South Texas Project Electric Generating Station P.O. Box 289 Wadsworth, Texas 77483

November 29, 2010
U7-C-STP-NRC-100253

South Texas Project
Units 3 and 4
Docket Nos. 52-012 and 52-013
Revised Response to Request for Additional Information

RAI 03.04.02-6, Revision 2**QUESTION:**

Figure 3.4-1
Non-Breaking Wave Force on Vertical Wall

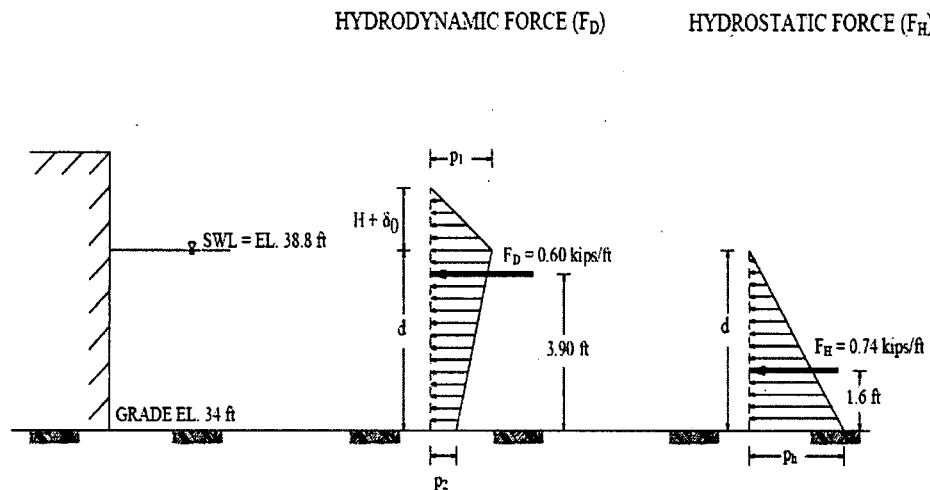
In its response the applicant has not evaluated the effect of water waves that may propagate on the water surface of the governing flood event. In its response to RAI 03.04.02-1 (RAI 3322 Question 13161), the applicant also referred to responses to four other RAIs (RAI 03.08.01-4, RAI 03.04.02-2, RAI 03.04.02-4, and RAI 03.04.02-5) for the resolution of RAI 03.04.02-1. The applicant is therefore requested to evaluate the effect of water waves that may propagate on the water surface of the governing flood event, and to track the closure status of the above noted four RAIs. The staff needs this information in order to be able to conclude that the above defined DBF effects are adequately accounted for in the design of Seismic Category I SSC pursuant to SRP Section 3.4.2.II(3).

The resultant hydrodynamic wave force is calculated to be 603 pounds (0.6 kips) per foot length of the vertical wall corresponding to the maximum breach flood level of 38.8 feet. The wave force diagram is shown in Figure 3.4-1, included with the COLA mark-up at the end of this response.

As seen from Figure 3.4-1, the total hydrostatic and hydrodynamic pressure at grade elevation 34'-0" is 339 psf (i.e. considering a sediment-laden water density of 63.85 lb/ft³, 306.5 psf + 32.5 psf = 339 psf). This pressure is less than the hydrostatic pressure due to conservatively established design basis flood level of 40'-0" (i.e. 6 x 63.85 = 383 psf). Therefore, inclusion of wind generated wave forces does not affect design of below grade walls.

As discussed in Section 2.4S.4.2.2.4.3, the hydrodynamic force due to the wind-generated wave action on building walls has been calculated as shown in Figure 3.4-1.

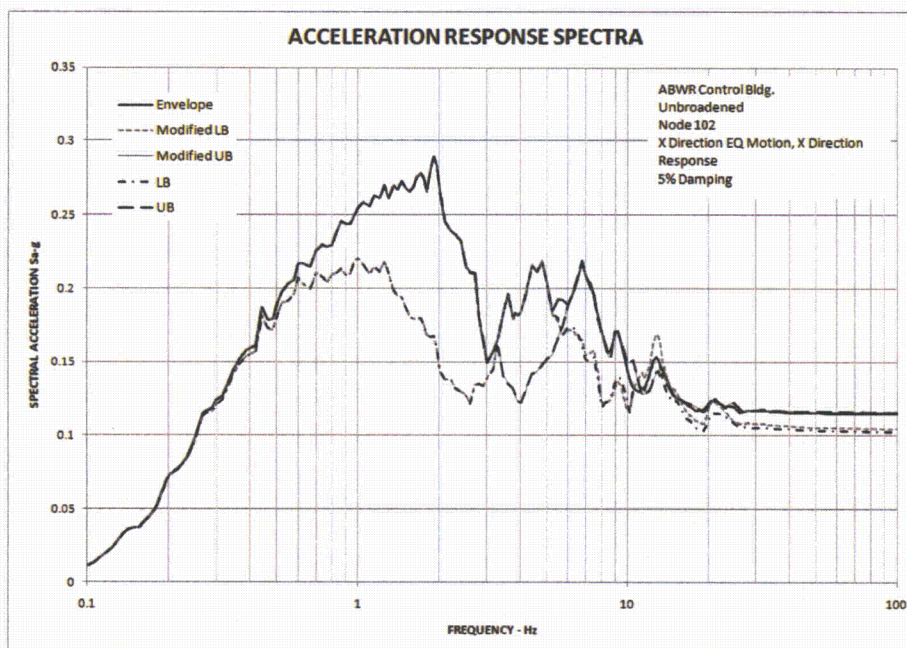
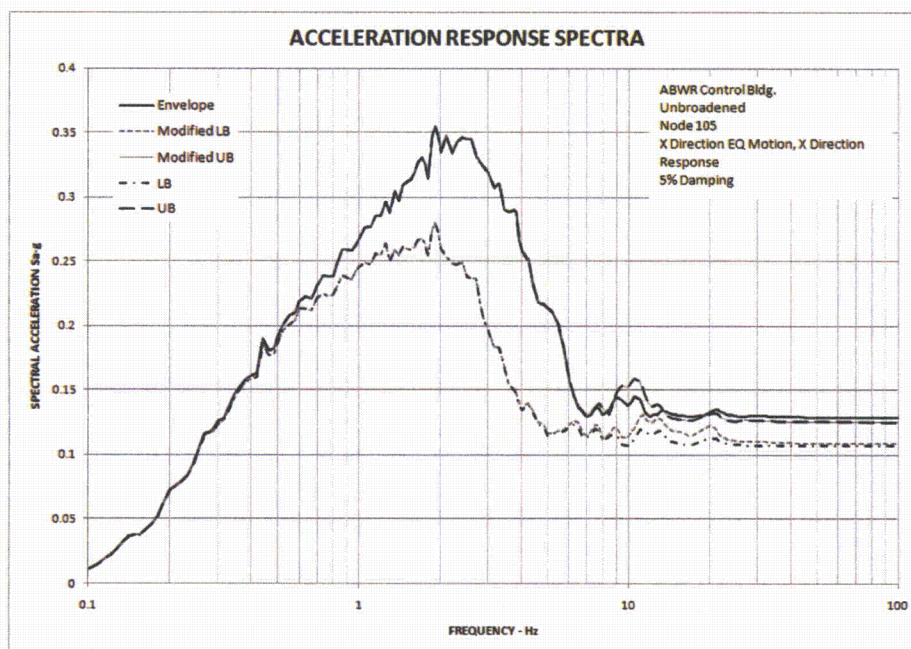
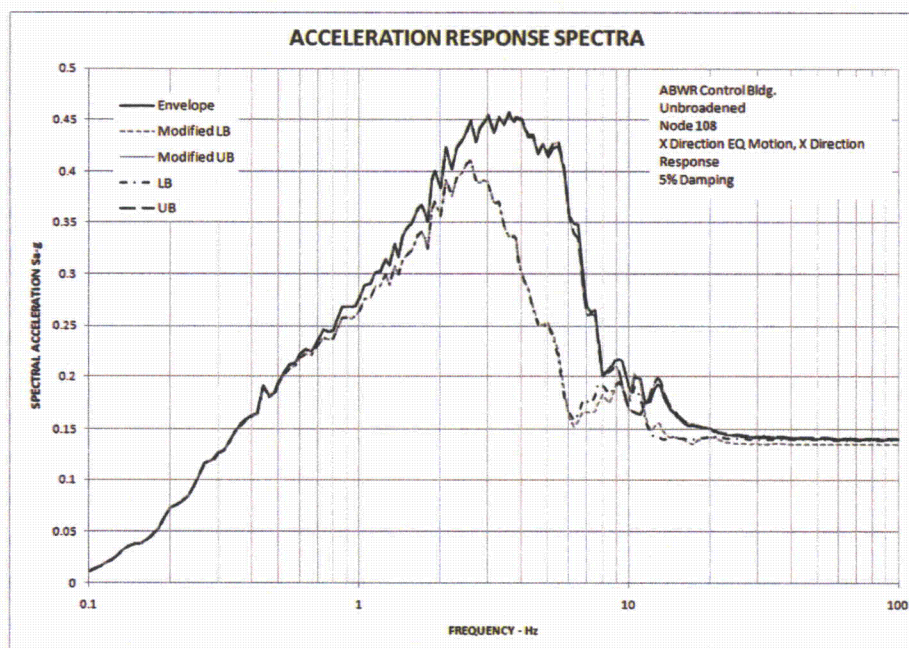
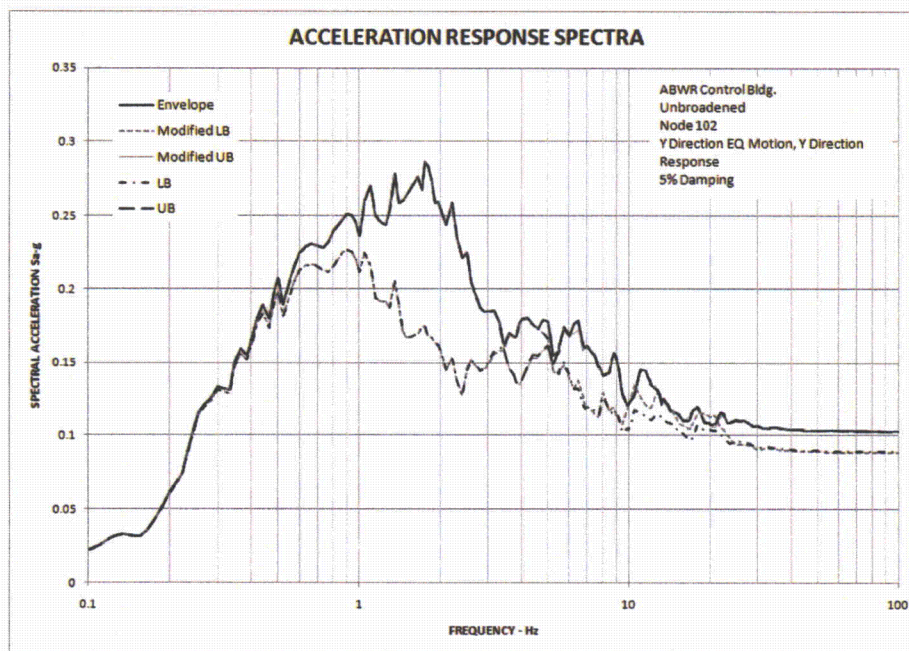
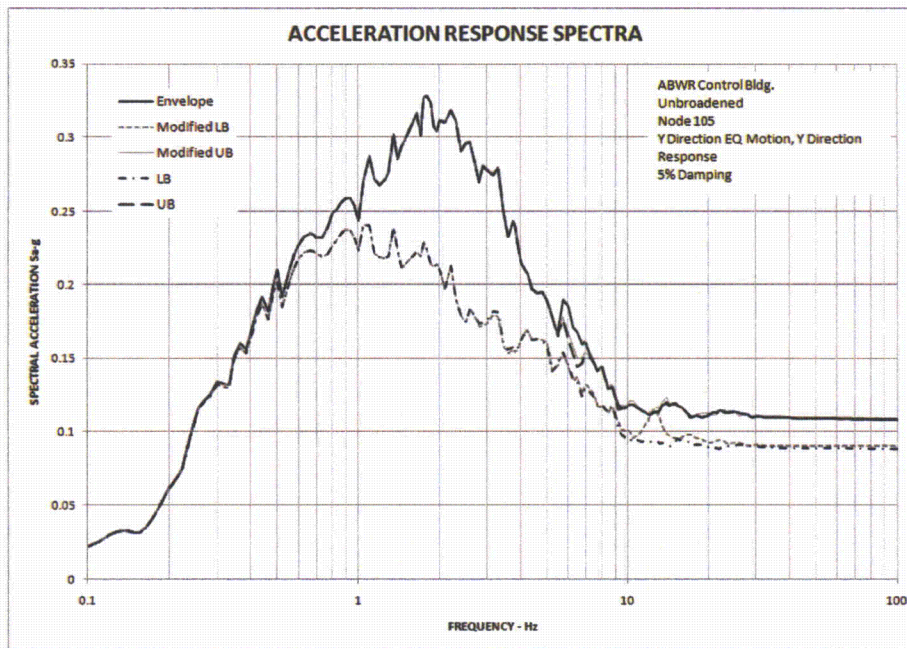
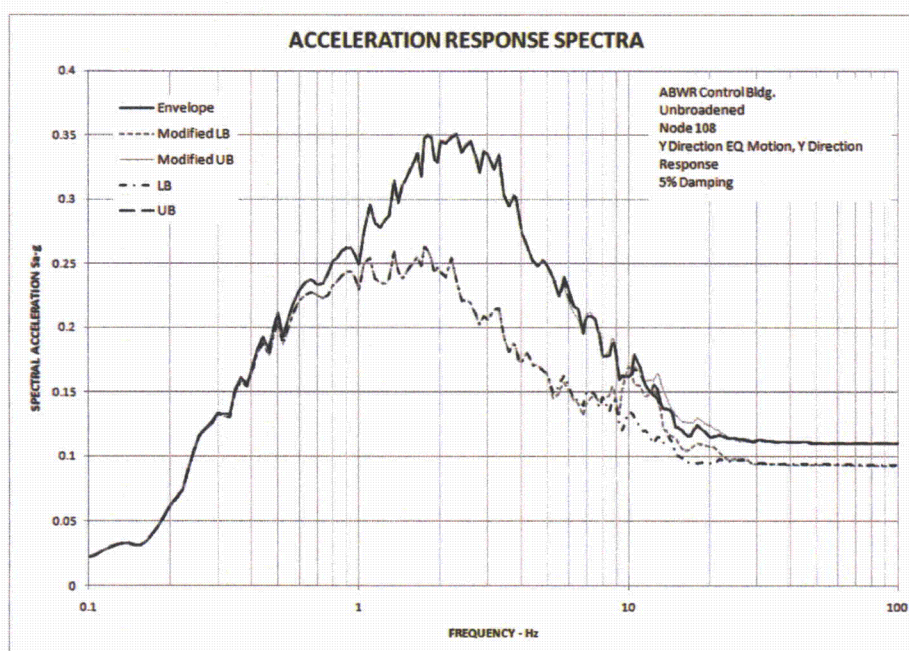
3. In the response to Item 2 of RAI 03.07.01-17, the applicant has stated that the Poisson's ratio has been capped at 0.48 for saturated soils in calculating the compression wave velocity. This results in calculated compression wave velocities lower than 5000 ft/sec in saturated soils when the shear wave velocities drop below approximately 980 ft/sec. For example, as shown in Tables 3H.6-1b through 3H.6-2c (see the enclosure to STP's response to

Horizontal spectra in the X (north-south), and Y (east-west) directions are compared in Figures 03.07.01-25.9 through 03.07.01-25.14. These comparisons show the following results:

- The LB modified spectra are about the same as the corresponding LB original spectra for frequencies lower than 6 Hz with small difference at higher frequencies. In Figures 03.07.01-25.9 through 03.07.01-25.14, these spectra are also compared with the corresponding original envelope spectra. The comparison shows that the envelope spectra, in general, envelop the LB modified spectra. The UB modified spectra are about the same as the corresponding UB original spectra in the entire frequency range, with only insignificant differences.

- In summary, the horizontal response spectra calculated using modified soil properties are enveloped by the original envelope spectra with the exception that some are greater than the envelope by less than about 0.02g at some frequencies, such as around 12.8 Hz in Figure 03.07.01-25.9, around 10.5 Hz in Figure 03.07.01-25.10 and around 13 Hz in Figure 03.07.01-25.14.

**Figure 3H.6-212: Lateral Seismic Soil Pressures (psf) on RSW Piping Tunnel East Wall
(Main Cross Section of RSW Piping Tunnel)**

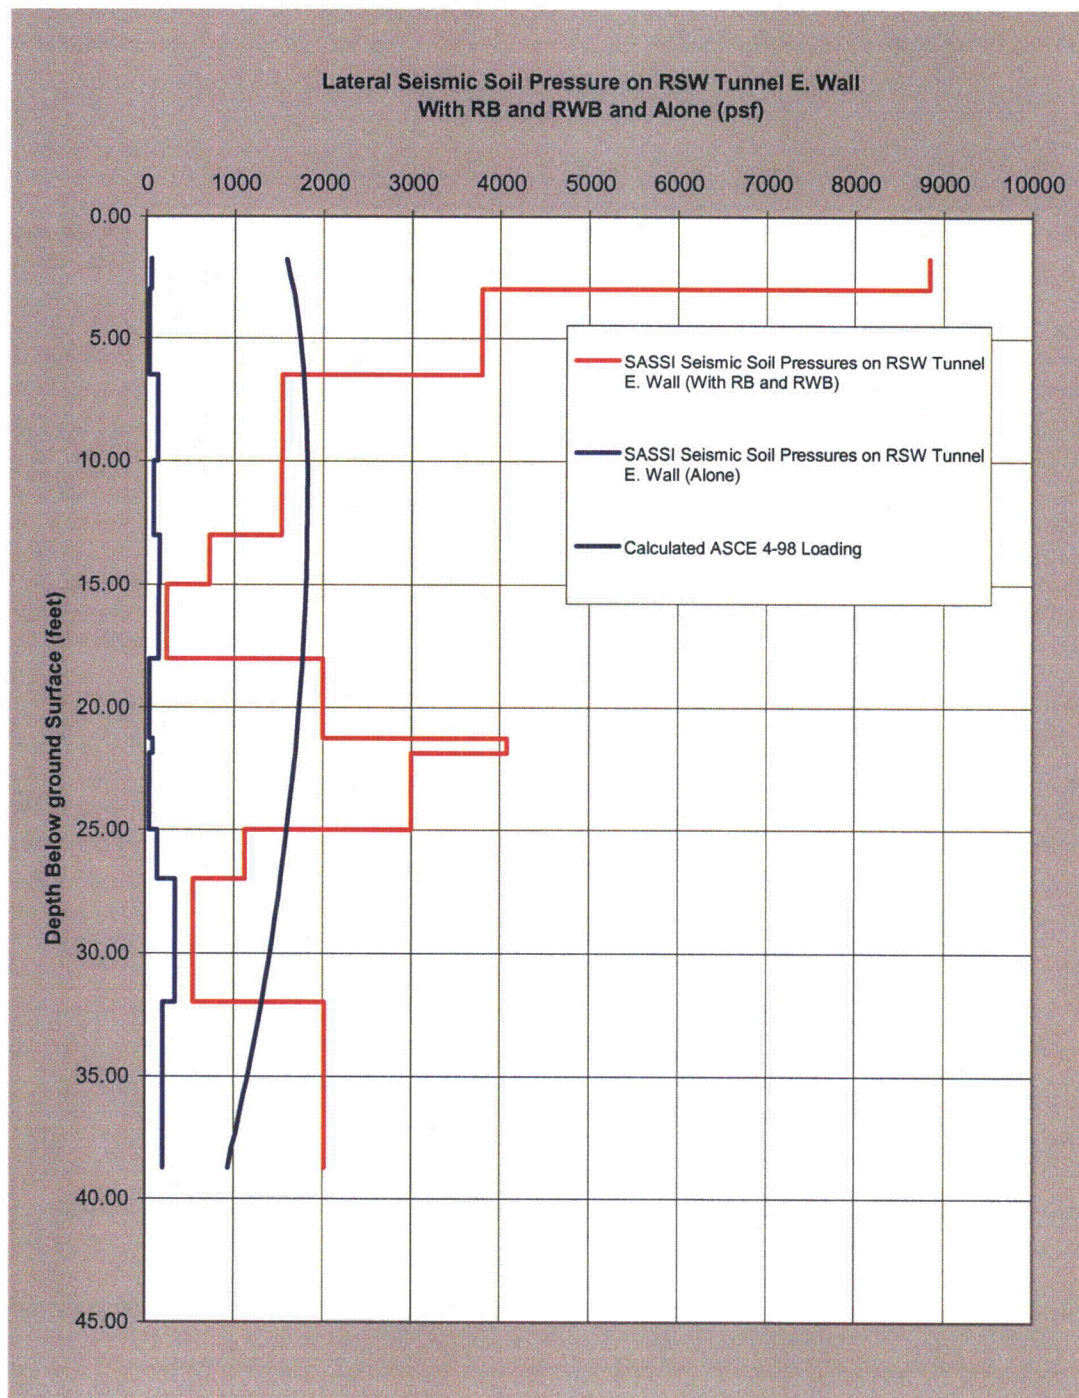
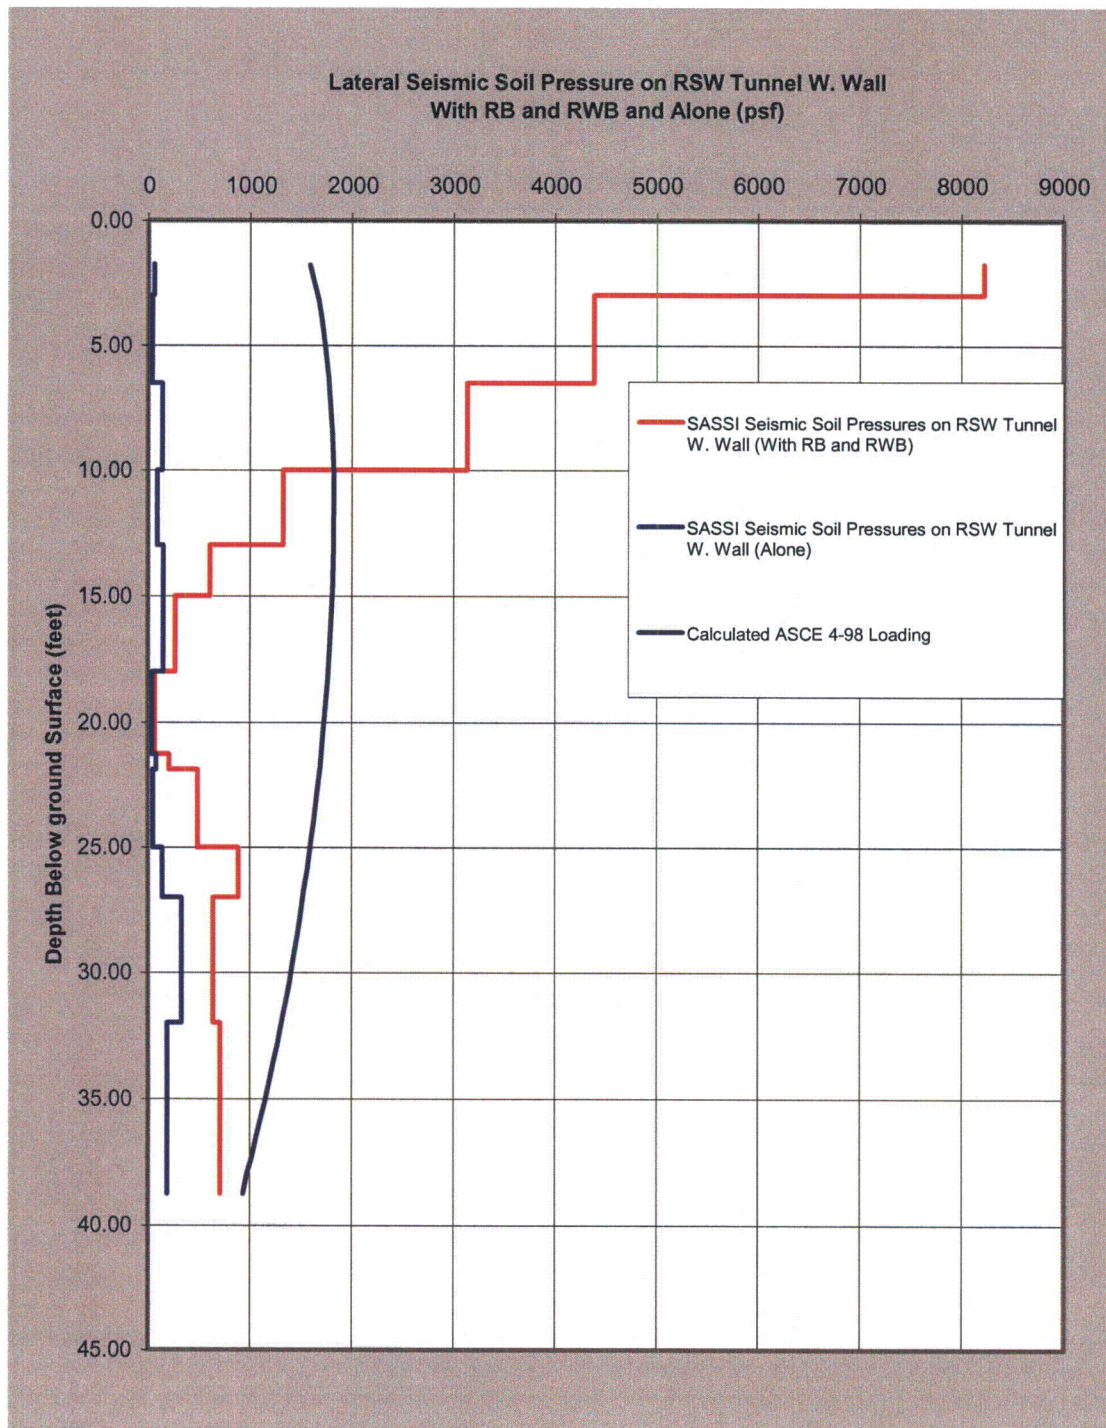
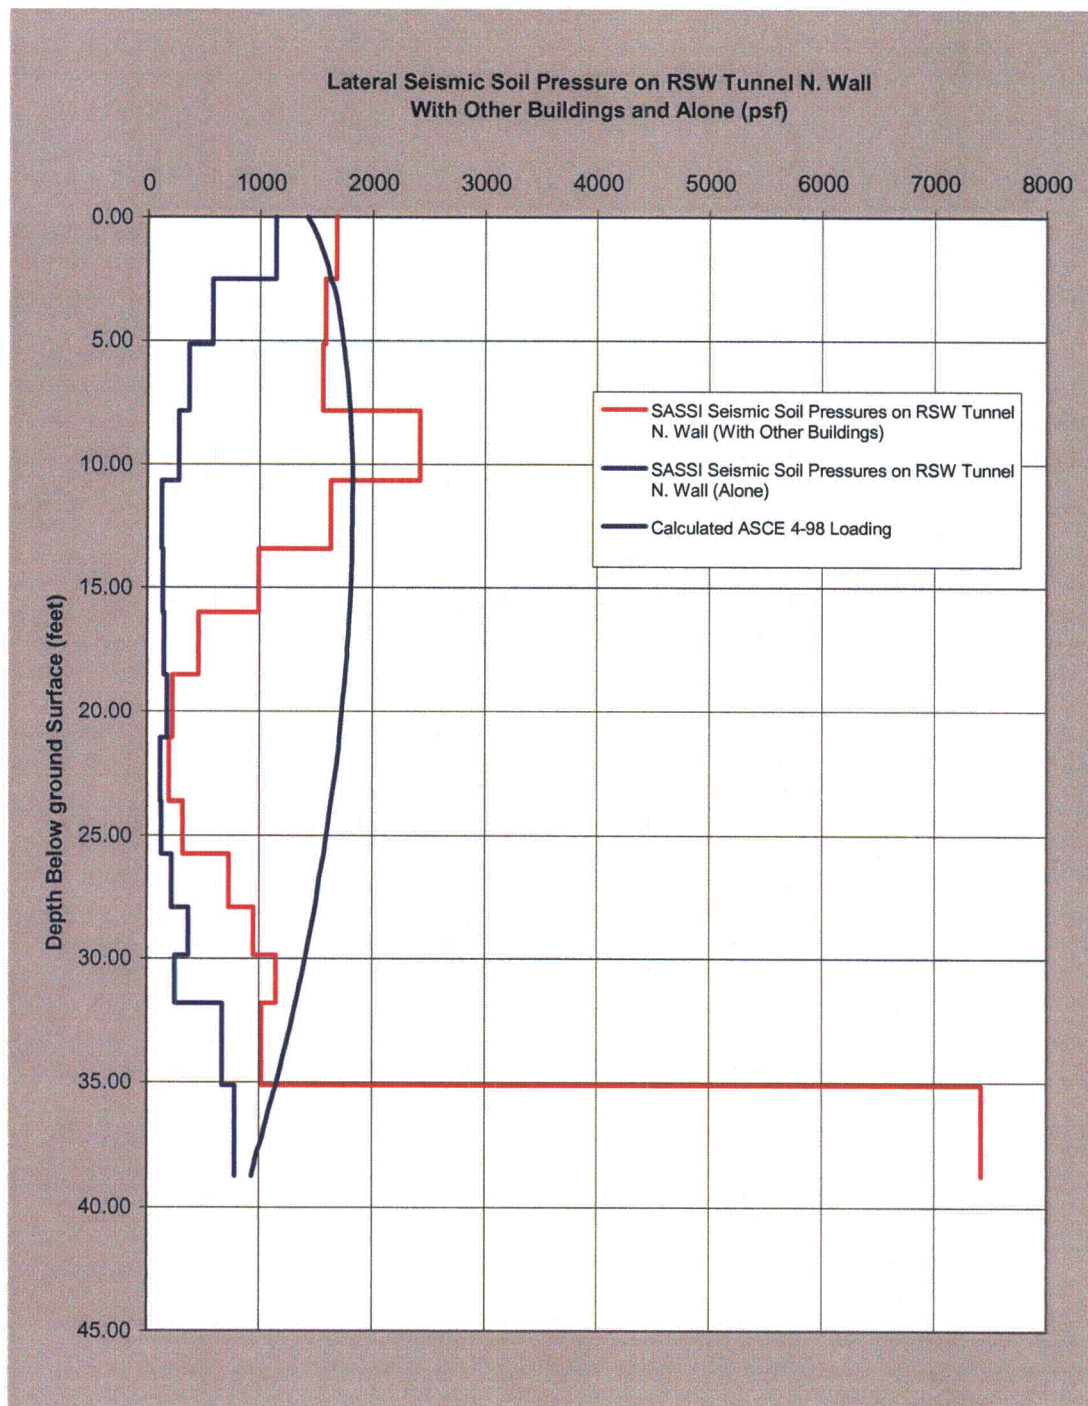
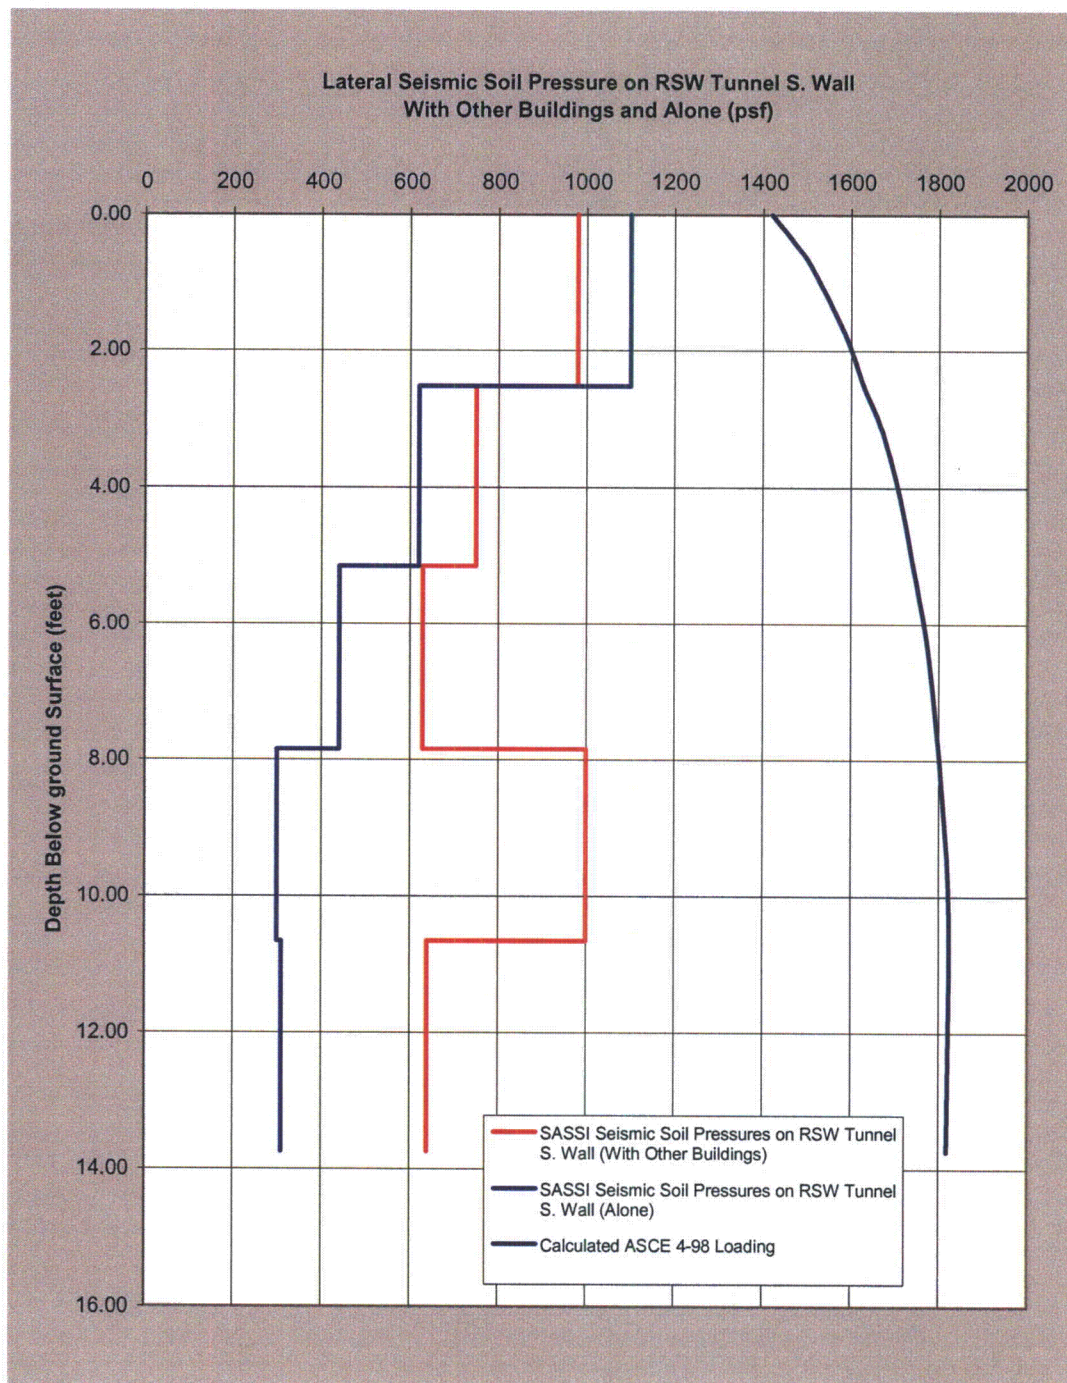
- a) Staff has not endorsed ASCE 4-98 Section C3.3.3.4 as acceptable criteria for selecting the cutoff frequency for the SSI analysis for detailed finite element model such as UHS Basin with cooling tower enclosure and RSW Pump House. The applicant is requested to provide comparisons of in-structure response spectra at some selected locations by increasing the frequency cut-off to a minimum of 33 Hz and using a SSI model capable of transmitting a frequency up to 33 Hz (refer to Follow-up Question to RAI 03.07.02-17) for all analysis cases considered demonstrating that cut-off frequencies used in the SSI analysis are acceptable. The staff needs this information to ensure that the selected cut off frequencies less than 33 Hz in SSI analysis will accurately or conservatively account for the expected frequency content of the SSE in the SSI analysis.

Figures 3H.6-212 through 3H.6-215 provide the requested comparison between the seismic soil pressures from the SSSI analysis, as described in Part 1 above, and the calculated seismic soil pressures per ASCE 4-98. The existing design as discussed in response to RAI 03.07.02-15 (submitted with letter U7-C-STP-NRC-100036 dated February 10, 2010) was re-evaluated for the resulting seismic soil pressures from the SSSI analysis. Although the existing design was found to be adequate for these SSSI soil pressures, a portion of the design for the access region near the UHS/RSW Pump House was revised due to design development. COLA Part 2, Tier 2 Table 3H.6-6 is revised to reflect this design change.
